May 30, 2025 PROJECT NAME: ARDEN OF OCALA PROJECT NUMBER: 2007120013 APPLICATION: REZONING TO PUD WITH MASTER PLAN #32799

MASTER PLAN - 2 (NOTES)

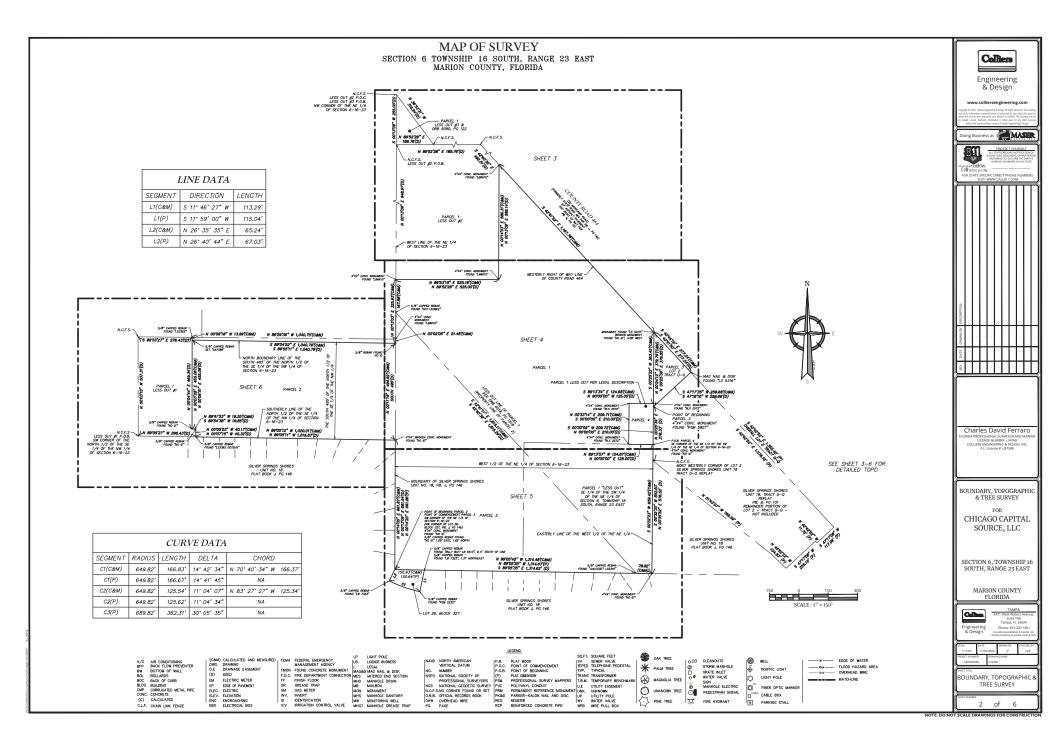
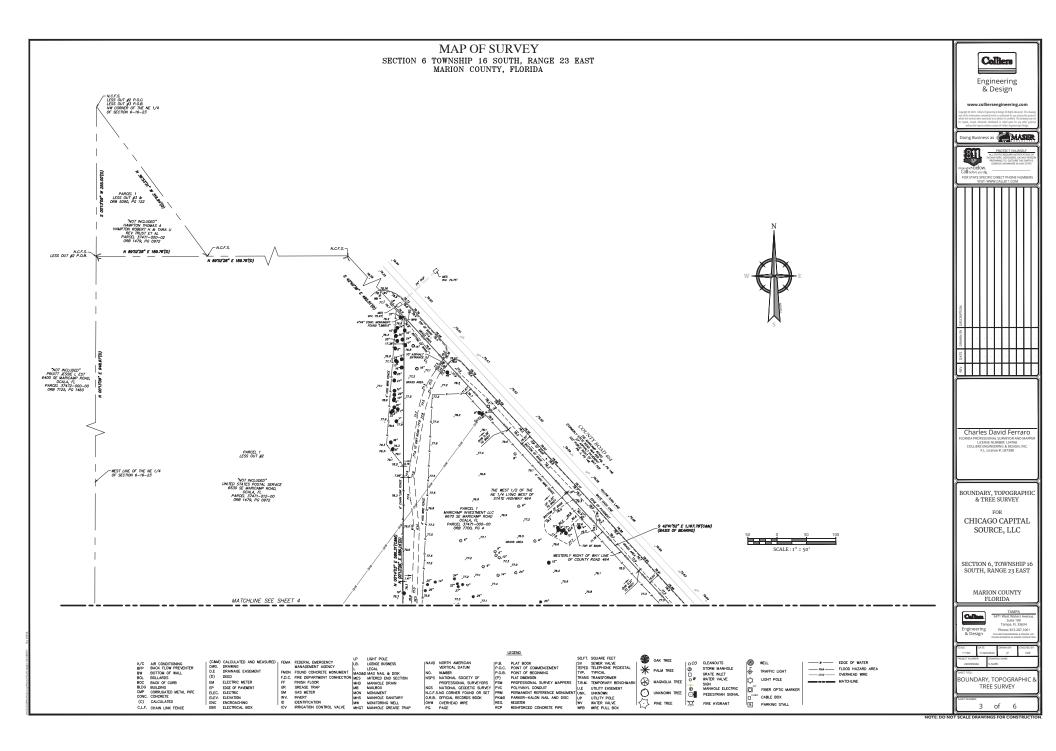
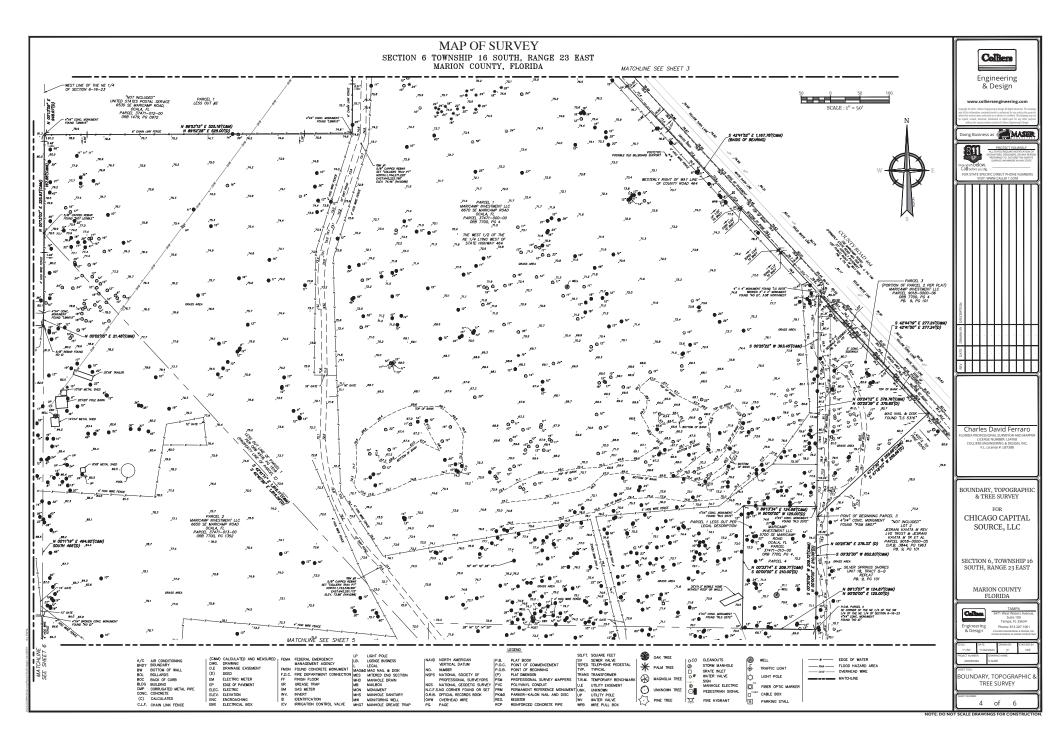
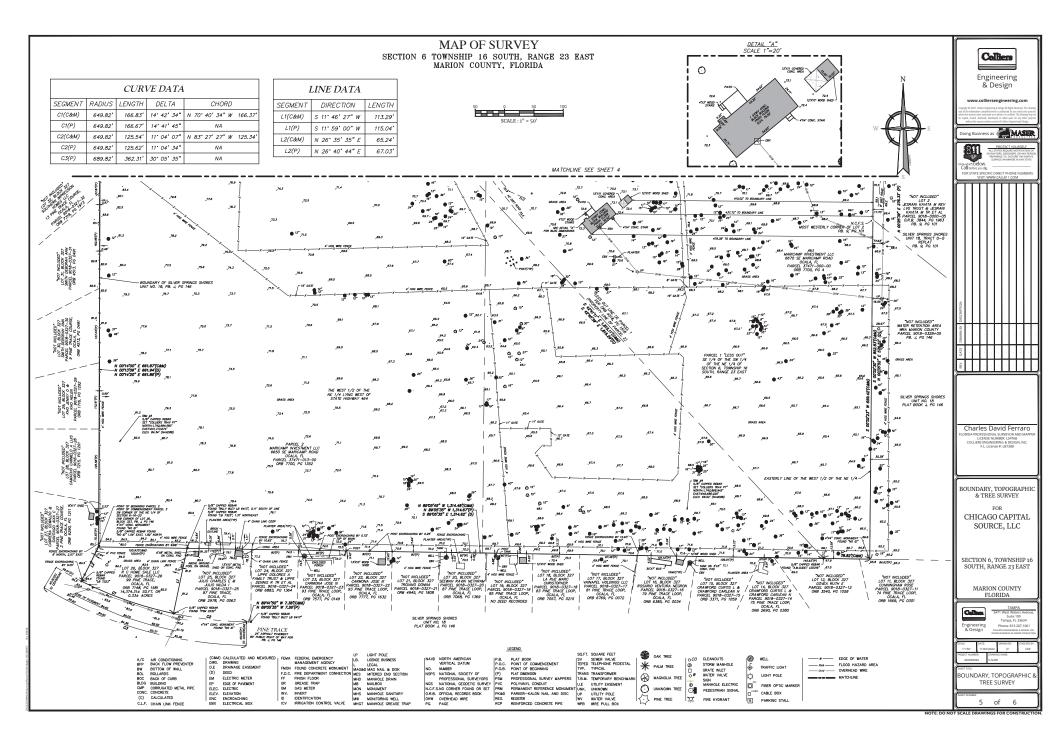
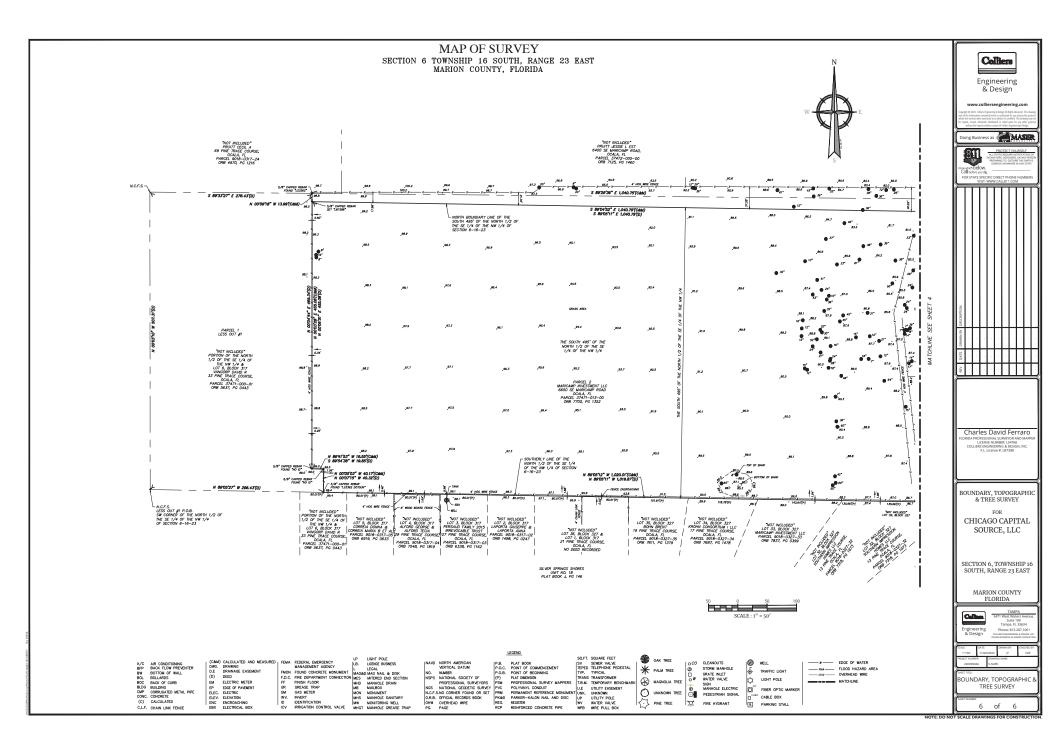
REMARKS: Note 1 on page 3 of plans states this project is 60.7 acres while the site coverage and summary of land use entitlement states figures are provided based on 61.4 gross acres. Density allocation for proposed PUD states 9.78 acres for commercial and 58.3 acres for residential which is 68.08 acres. Please provide consistent information for acreage.

[1] Important PUD note on sheet "MASTER PLAN - 2 (NOTES)" states that the PUD will meet the conditions of Resolution No. 23-R-46. Condition 2 states that the commercial component of the PUD is limited to B-2 zoning classification uses and standards.

There does not seem to be explicit mention of B-2 development zoning standards in the notes. The appropriate setbacks are noted, but not explicitly tied to B-2 standards. There is no reference to commercial building height, permitted uses, etc. allowed in B-2. These standards and permitted uses are required (see LDC Sec 4.2.31.B & E.)

Provide a note acknowledging and outlining B-2 standards.

[2] Note #6 on the Notes sheet states an apartment will be set back 24 feet from an R-1 zoned property, currently used as a DRA. The applicant provides 60-foot height standards for apartments which conflicts with Sec 4.2.31.E(4)(b)2.b. However, the applicant is allowed to propose the 24 feet setback. Add additional context to the Notes justifying this apartment to remain 60-foot/3-stories.
